ADDENDUM
NO. 2

May 28, 2020

Additions & Renovations to Lawrence Central High School
7300 E.56th St.
Indianapolis, IN 46226

ADDENDUM NO. 2
MAY 28, 2020

1B PIPE HANGER (6" & SMALLER) DETAIL
NOT TO SCALE

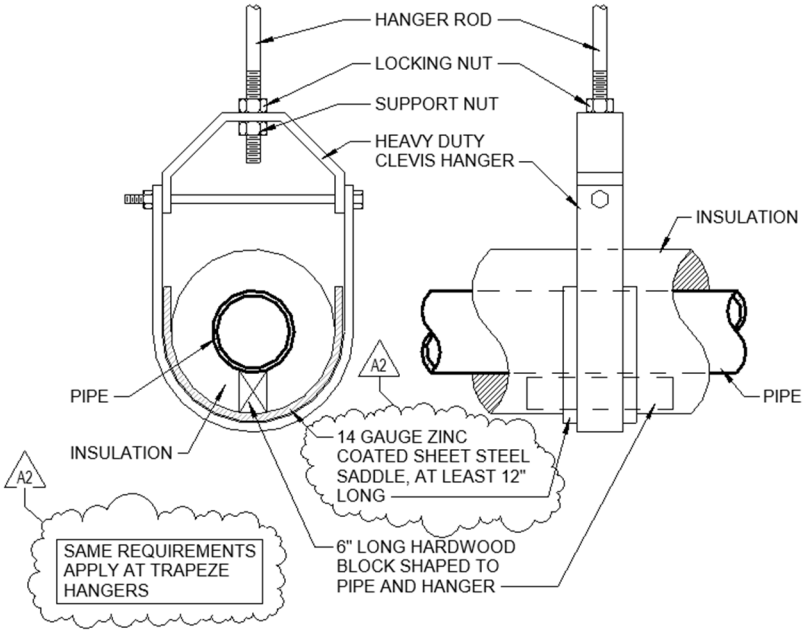
1. Modify Detail 1B as seen below:

2B PIPE HANGERS (8" & LARGER) DETAIL
NOT TO SCALE

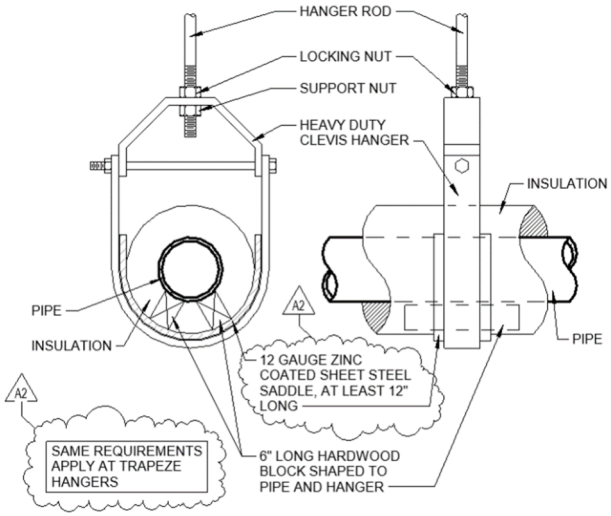
2. Modify Detail 2B as seen below:

D. Sheet Number P-909

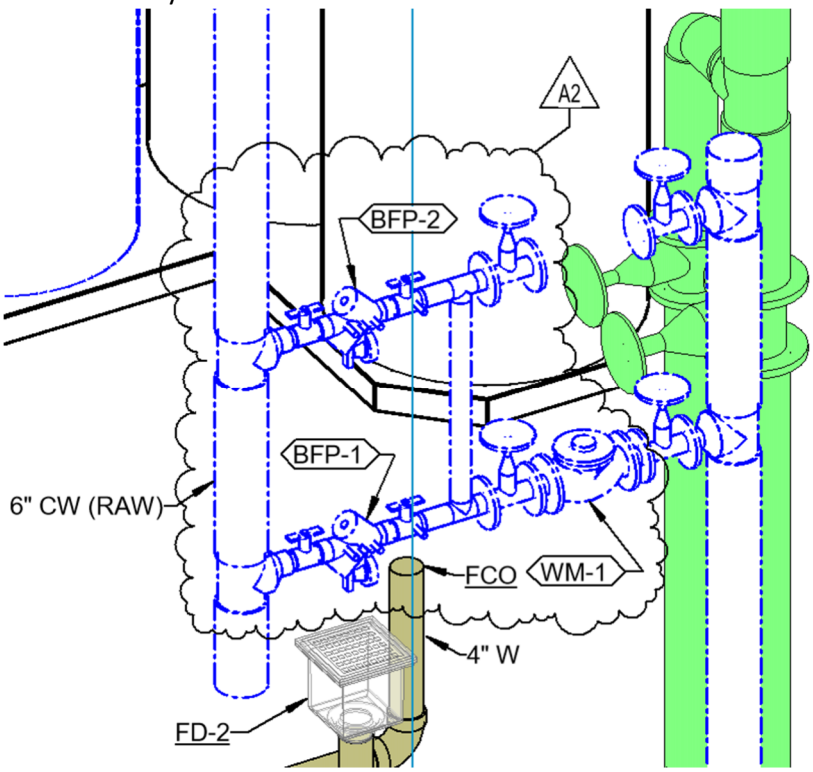
1. Modify Detail 4A as seen below:
